# Target R&D plans and thoughts on target complex magnetization

*SHiP 8<sup>th</sup> CM – Imperial College 13<sup>th</sup> June*

# Comments on target region magnetization

# RP consequences

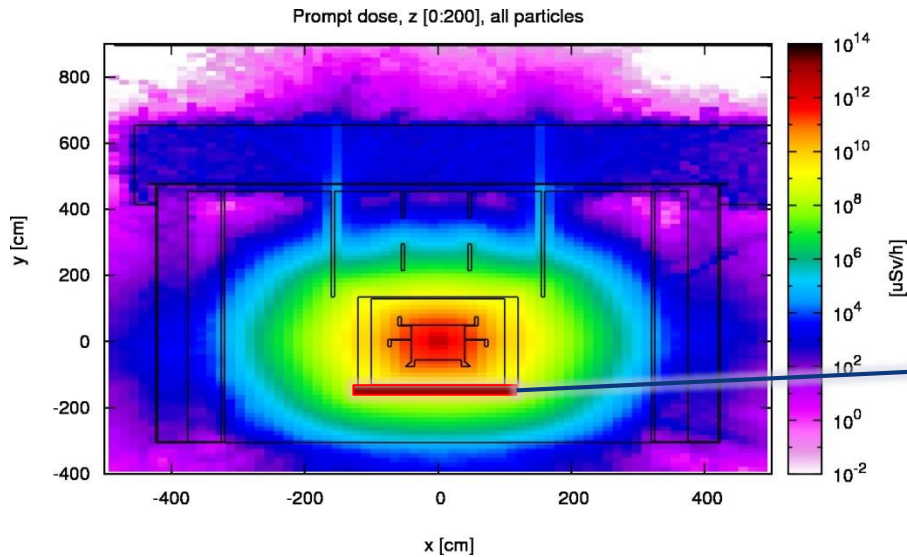
- Take into account that radiation levels will be **extreme** during operation  **$\sim 10^3$  Sv/h** ( **$\sim O(10$  MGy/y)**)

- Residual dose rate** of the coils shall be assessed for a final conclusion
- Material selection should target **grades with low activation**
  - Al and  $Al_2O_3$  (coils & powering) are ok for operational RP and shall be considered as baseline, but will need to be validated by radioactive waste section at CERN
  - SS for high permeability material: low-Co steel ( $\sim 0.05\%$ ) mandatory

# Magnetization of target region (I/II)

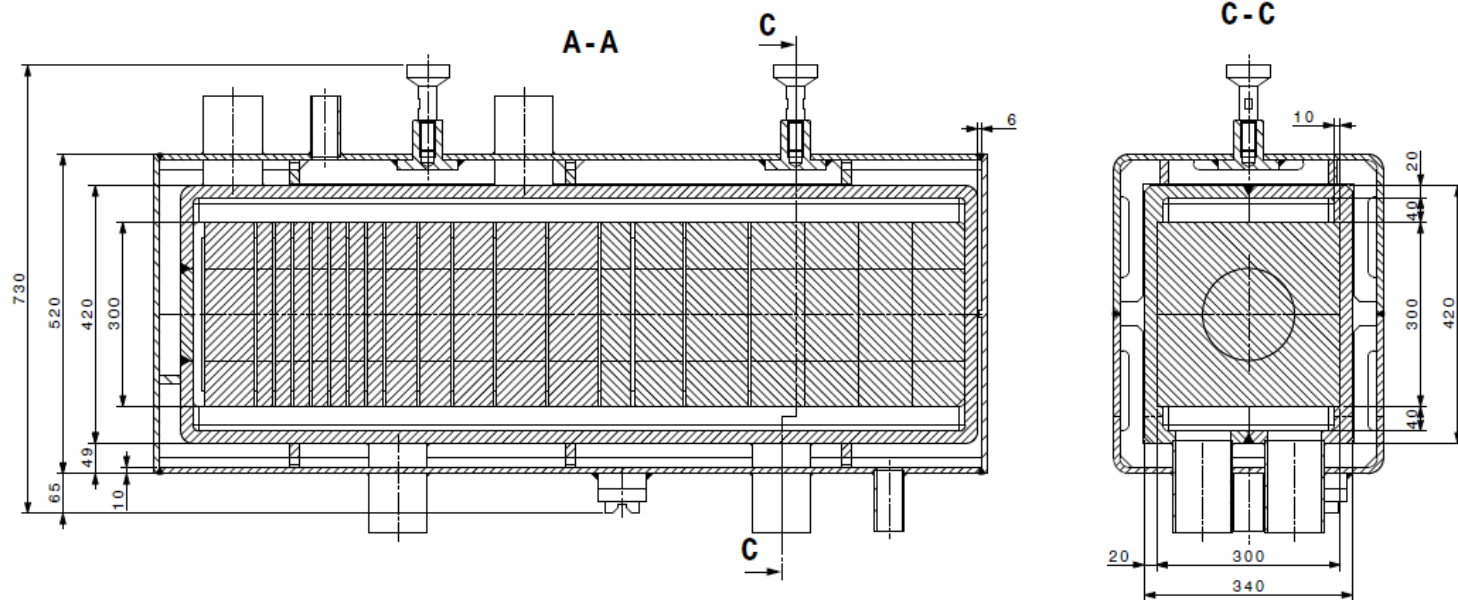
- Magnetizing proximity shielding (“Region 1”) and hadron absorber (“Region 2”) is **supported** and is **felt realistic**
- Magnetizing the inner bunker container (where target is located, “Region 0”) shall be **excluded at this stage** due to the presence of the target and related instrumentation
- Practically, the **implementation of the magnet system will significantly increase the complexity** of the target complex
- Integration of the system will be **challenging** – remote handling and manipulation aspects will be critical aspect to be analyzed early in the design
- **Reliability** is the key word: system must be able to withstand the high radiation environment during the whole lifetime of the experiment
  - Dose to personnel and radioactive waste generation!
